Subject: AP1000 Response to Request for Additional Information (SRP 3)

Response to Request for Additional Information on SRP Section 3

RAI Response Number: RAI-SRP3.8.3-SEB1-03

RAI Response Number: RAI-SRP3.8.4-SEB1-04

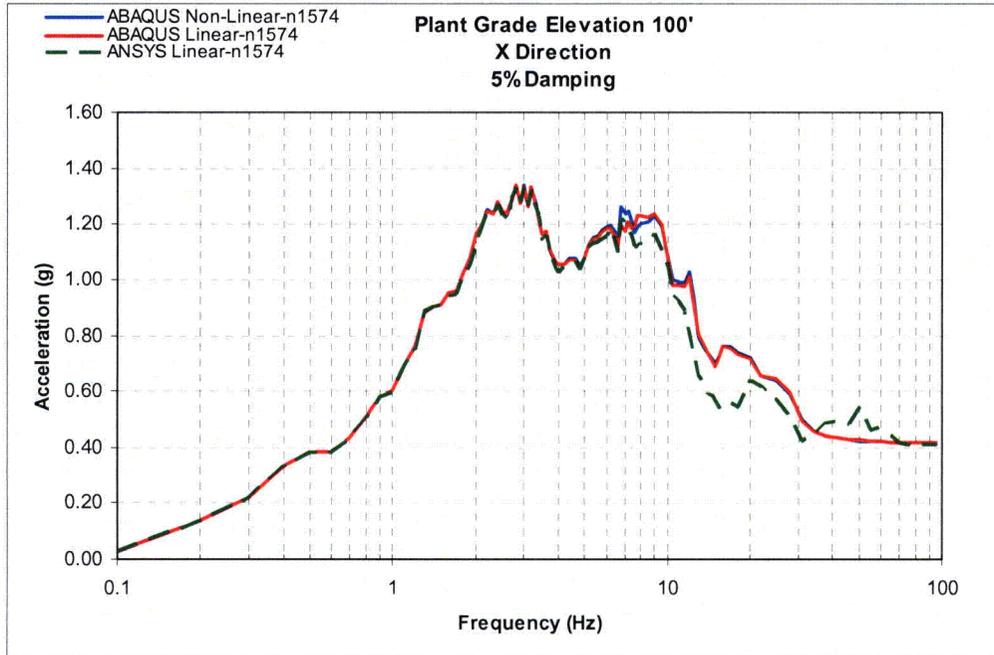
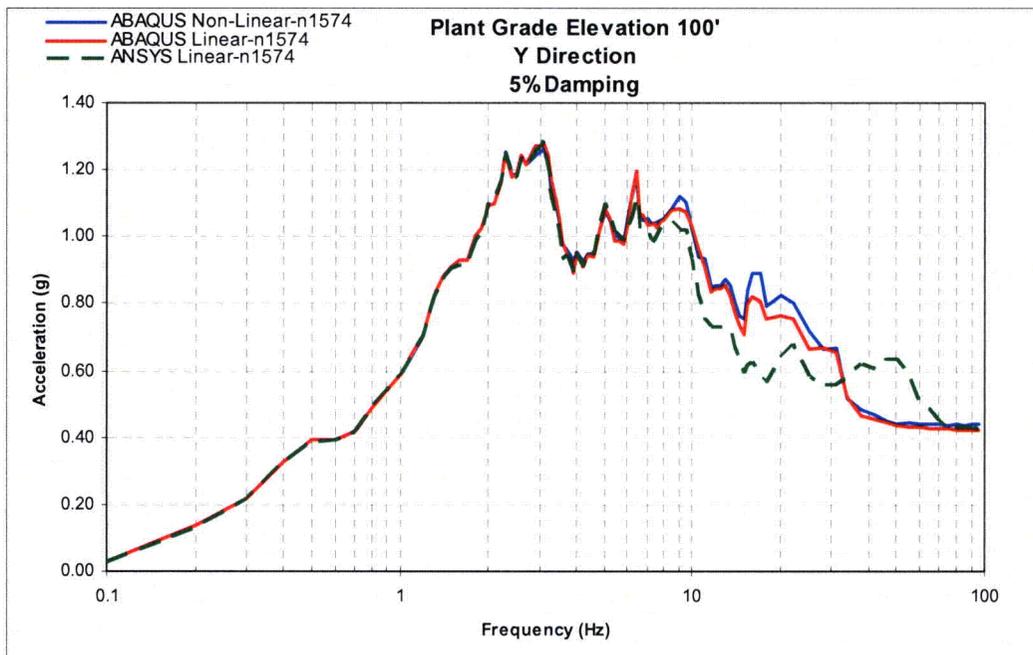
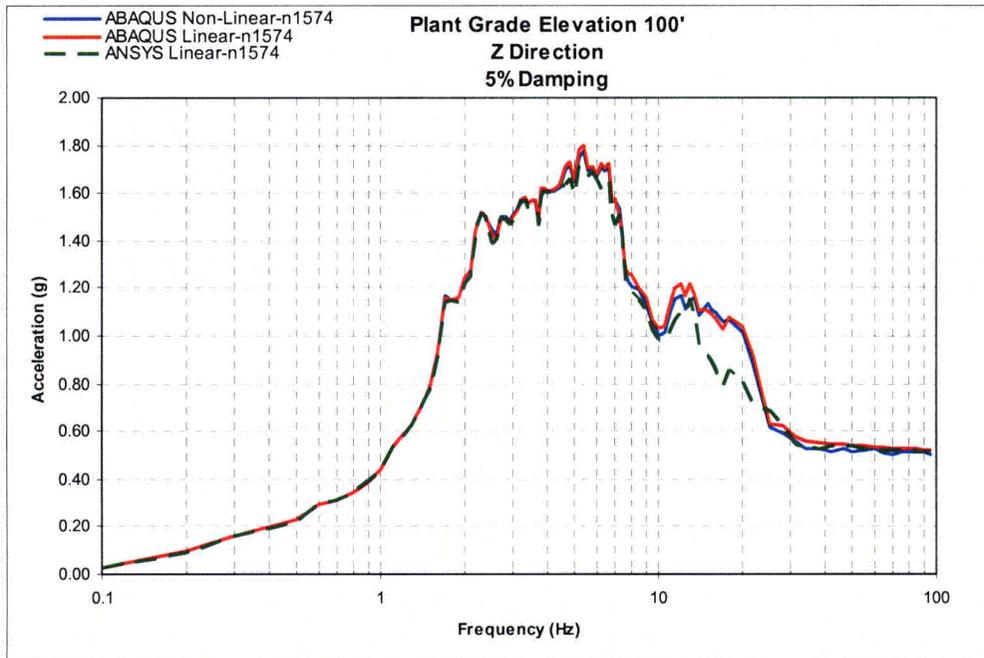
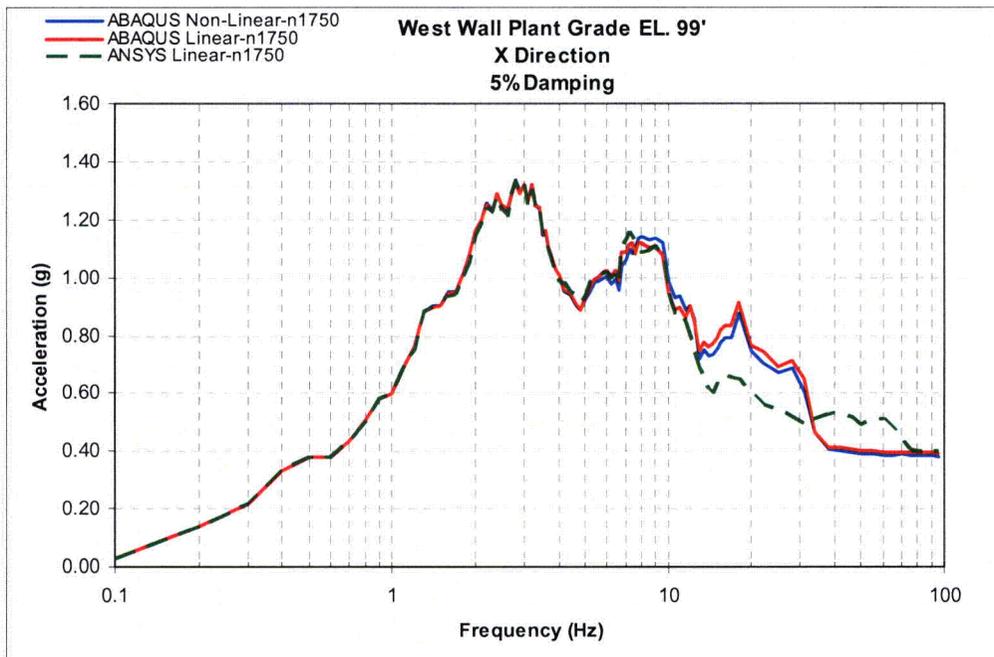
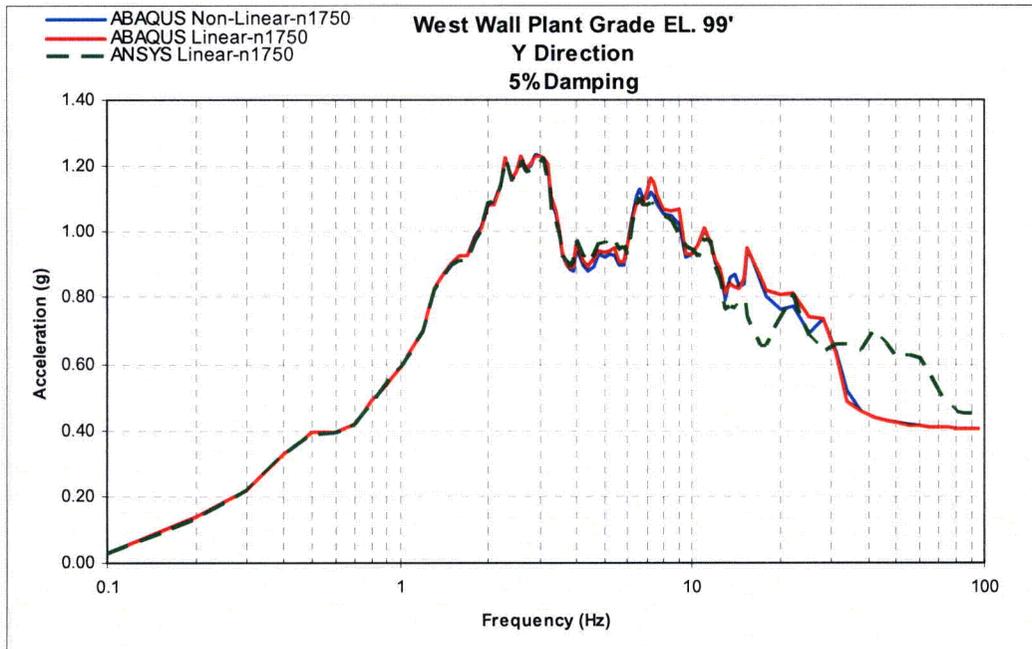
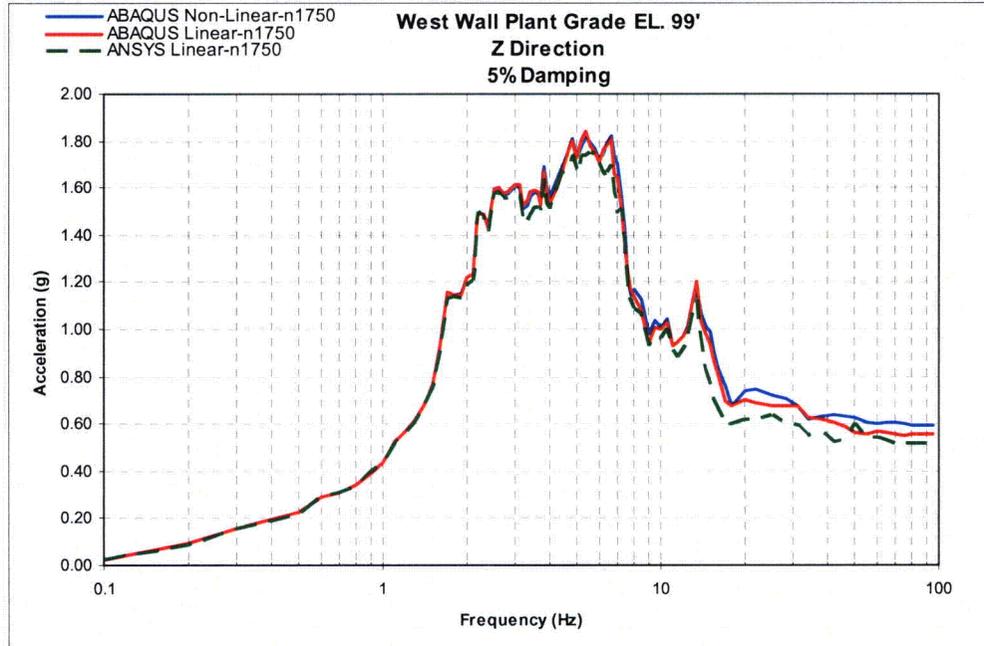
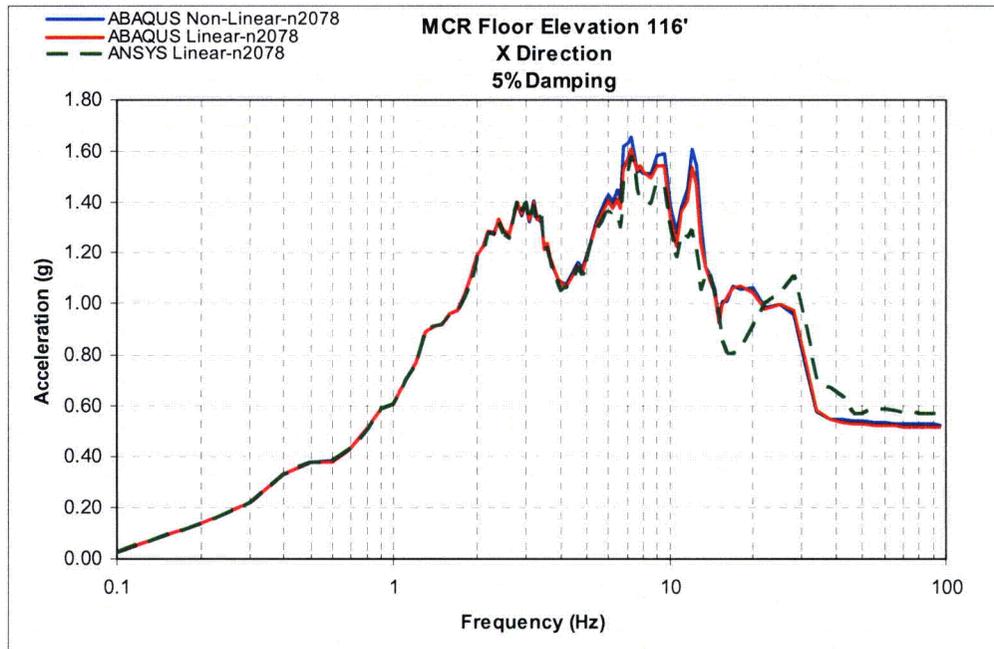
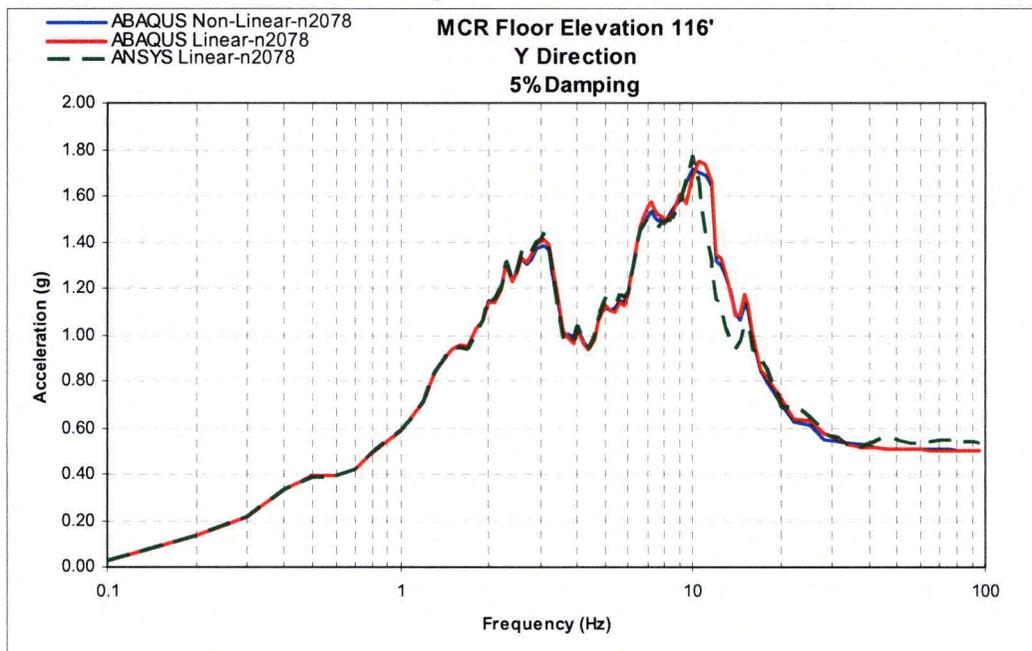
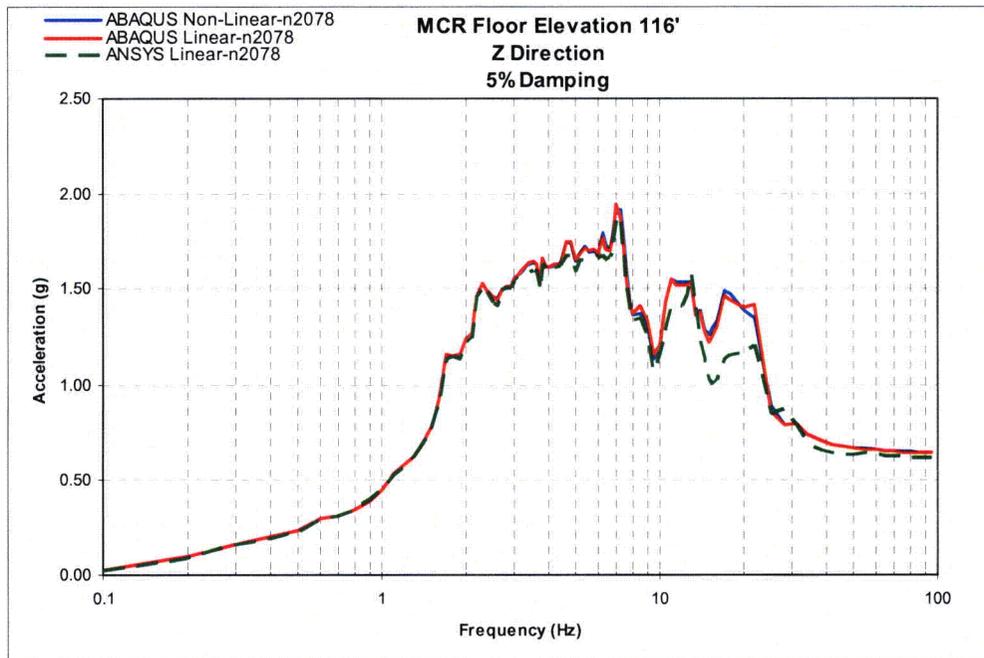
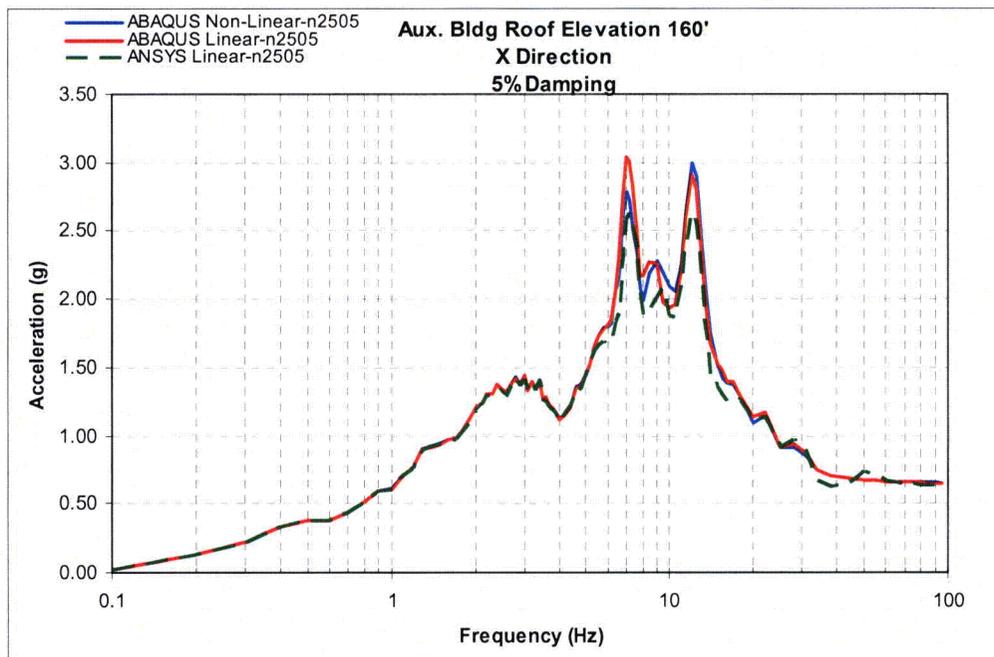
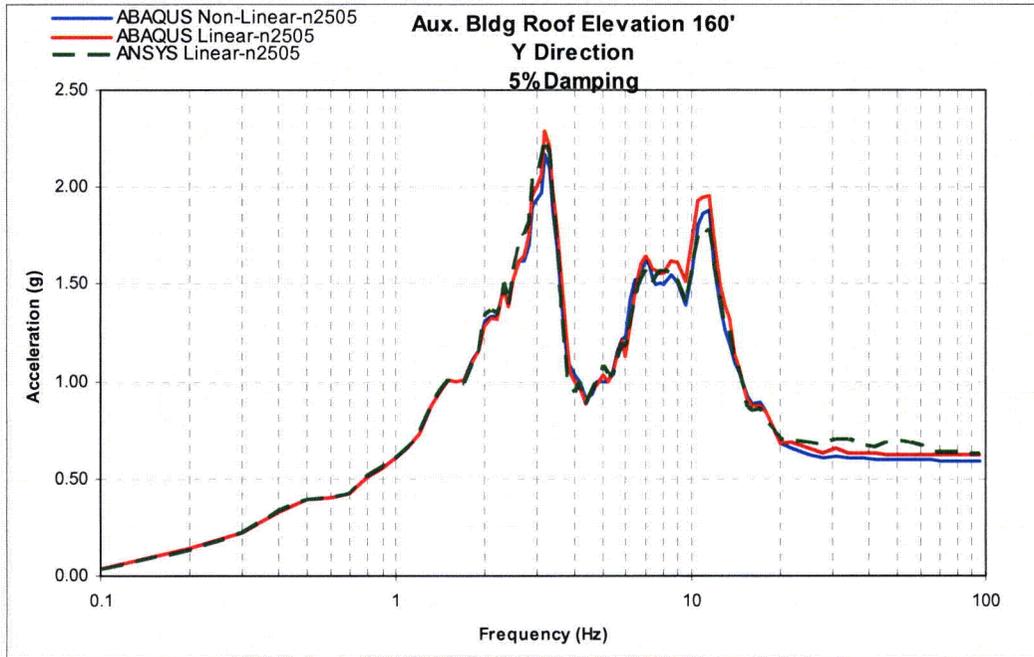
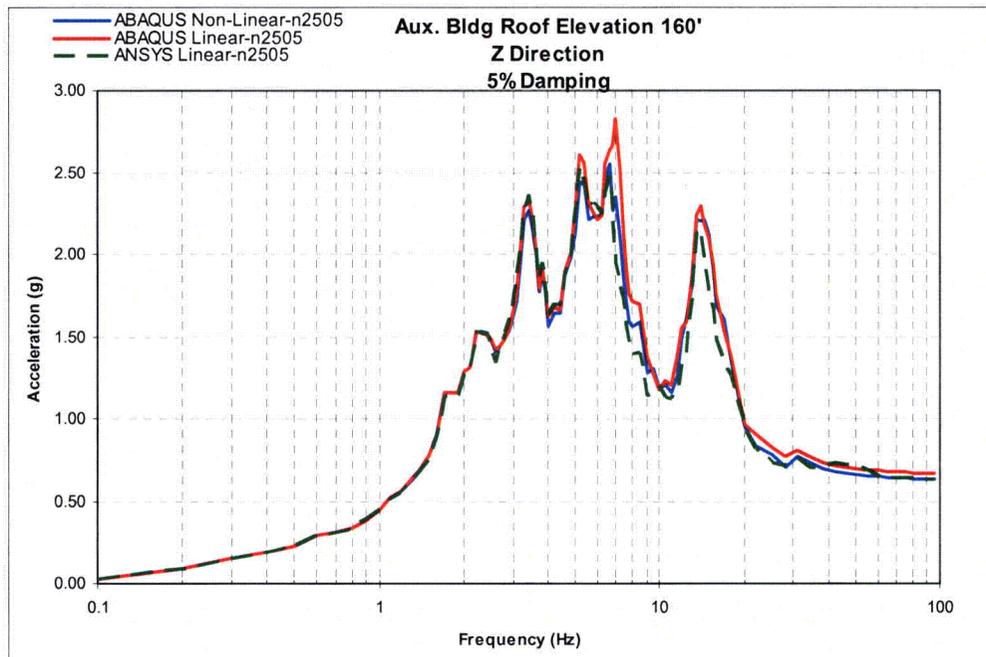
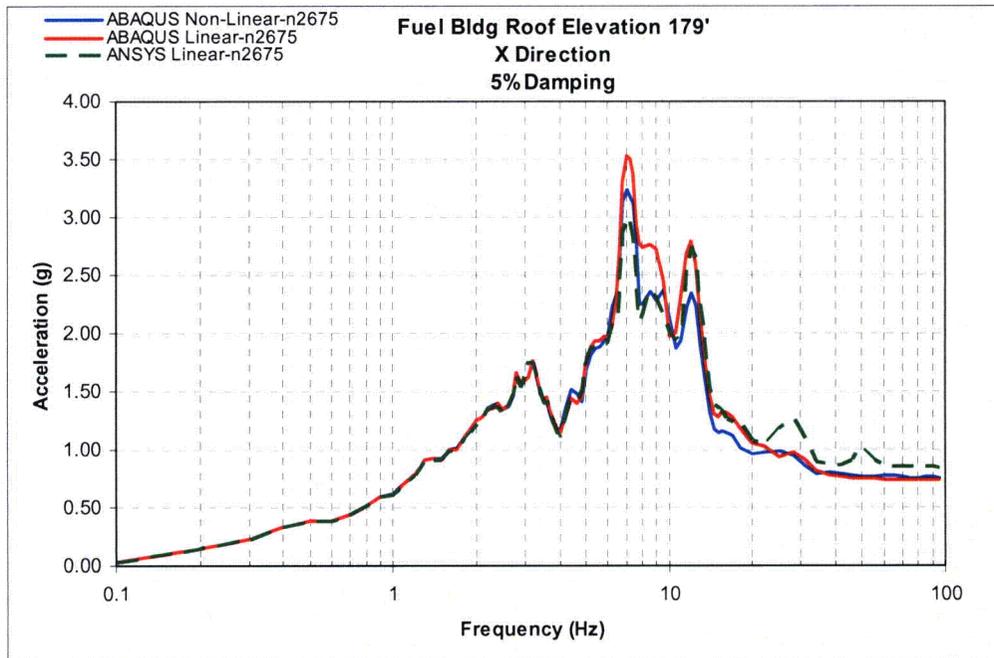
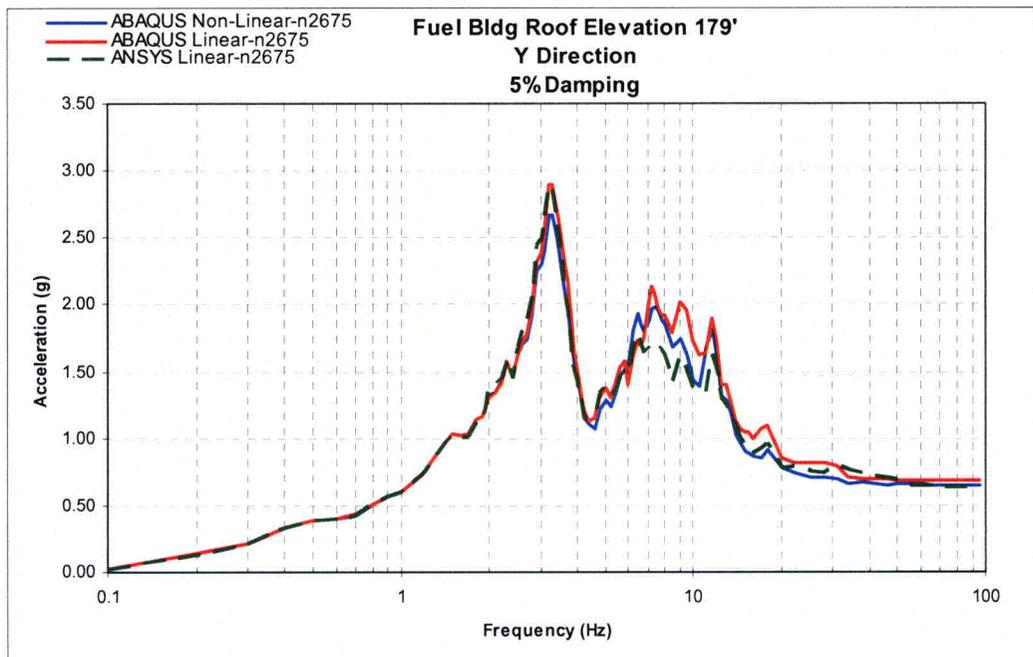
stiffness reduction factor. The staff requests WEC to add the corresponding ANSYS response spectra to Figures RAI-SRP3.8.3-SEB1-03-04 through RAI-SRP3.8.3-SEB1-03-21 in the RAI response, and to discuss any differences between the ANSYS linear results and the ABAQUS linear results. This is needed to ensure the adequacy of the ABAQUS linear model.

The Figures RAI-SRP3.8.3-SEB1-03-04 through RAI-SRP3.8.3-SEB1-03-21 from Revision 2 of this response have been updated to include the ANSYS linear comparison and are presented in Revision 3 Figures RAI-SRP3.8.3-SEB1-03-27 through RAI-SRP3.8.3-SEB1-03-44.

1. A list of critical nodes compared in this analysis is provided in Table RAI-SRP3.8.3-SEB1-01 in the Westinghouse Revision 2 response of this RAI. The FRS comparisons from the previous Revision of this RAI response have been updated to include additional information. These plots now show a comparison between the NI20 ANSYS linear, ABAQUS linear and ABAQUS non-linear models, and are provided in Figures RAI-SRP3.8.3-SEB1-03-27 through RAI-SRP3.8.3-SEB1-03-44.

The minor differences between the ABAQUS and ANSYS results are caused by a combination of the software's element calculation discrepancies as well as modeling modifications made to account for the limitations in FEM programs. The differences in results between the linear ABAQUS and ANSYS models are considered negligible when using the model for structural parametric studies. The FRS comparisons show good agreement up to 10 Hz where most of the structural damage is present. Two differences that affect the results, especially at the higher frequencies, are:

- Alpha Beta Damping - Leads to under damped frequency ranges in the model
- No CIS modeled in ABAQUS
